## MONTGOMERY COUNTY HISTORIC PRESERVATION COMMISSION

<b>Address:</b>	9923 Sutherland Rd., Silver Spring	<b>Meeting Date:</b>	1/27/2021
<b>Resource:</b>	Contributing Resource <b>Polychrome Historic District</b>	<b>Report Date:</b>	1/20/2021
<b>Applicant:</b>	James Gott (agent)	<b>Public Notice:</b>	1/13/2021
<b>Review:</b>	HAWP	<b>Tax Credit:</b>	yes
<b>Case No.:</b>	937866	<b>Staff:</b>	Dan Bruechert
<b>Proposal:</b>	Window Replacement

Staff recommends the HPC **approve with one (1) condition** the HAWP application.

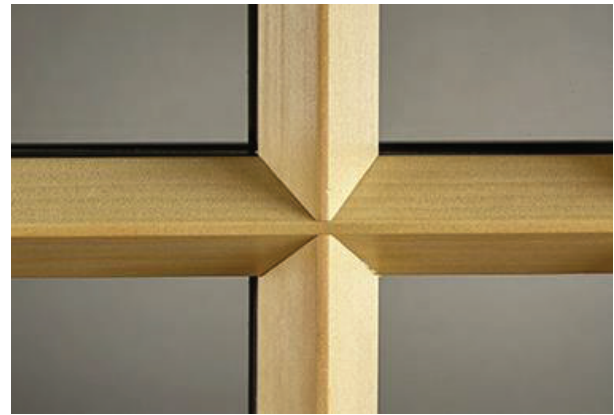
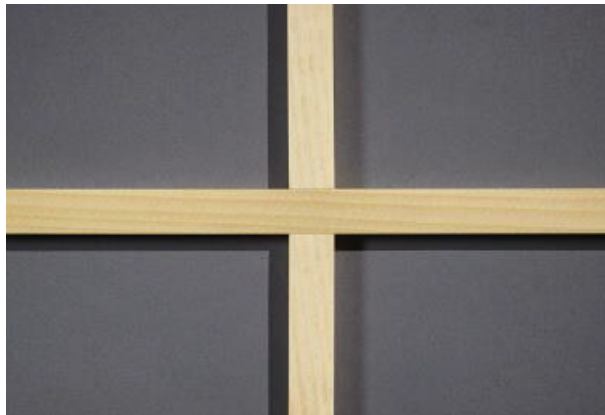
The final consideration is, do the proposed windows match other visual characteristics of the historic ones? Staff finds that for the most part, they do. The windows will be installed in the existing concrete openings, which have no trim. The 5/8" muntins are the approximate size of the existing muntins. However, Staff finds that the proposed square profiles of the muntins do not approximate the look of the steel muntins with their putty bevels. The VistaLux line is available with the option of either a square profile or a triangular profile. Both are shown below.

Staff finds that the triangular profile is a much better replication of the historic putty bevel, and while a small detail, creates much sharper shadow lines and makes the window appear less flat. Staff finds this small change will result in a significant improvement in the appearance of the windows. Staff recommends the HPC include a condition that the muntins need to utilize this triangular profile.

1. The exterior grilles need to have a triangular profile to match the appearance of the putty bevel in the existing, historic windows;
- under the Criteria for Issuance in Chapter 24A-8(b)(1), (2), (d), having found that the proposal, is consistent with and compatible in character with the purposes of Chapter 24A;
